AMENDMENT NO. 2 JUNE 2011
TO
IS 9537 (PART 3) : 1983 SPECIFICATION FOR CONDUITS FOR ELECTRICAL
INSTALLATIONS

PART 3 RIGID PLAIN CONDUITS OF INSULATING MATERIALS

FIG. 7 GAUGE FOR CHECKING MAXIMUM OUTSIDE DIAMETER OF SOCKET-END

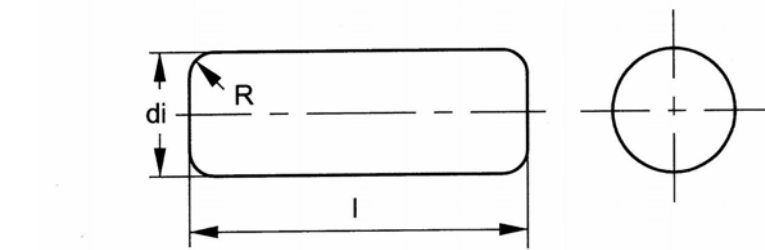
(Amendment No. 1, page 1, clause 7.1.1) — Substitute the following for the existing matter:

7.1.1 Compliance to the dimension of the socket may be verified with the help of gauges as shown in Fig. 7 and Fig. 8.

Size	Diameter, Max	b	d
16	20.1	12	45
20	24.5	12	45
25	29.8	16	60
32	37.8	18	70
40	46.1	18	70
50	57.3	20	85
63	69.6	20	100
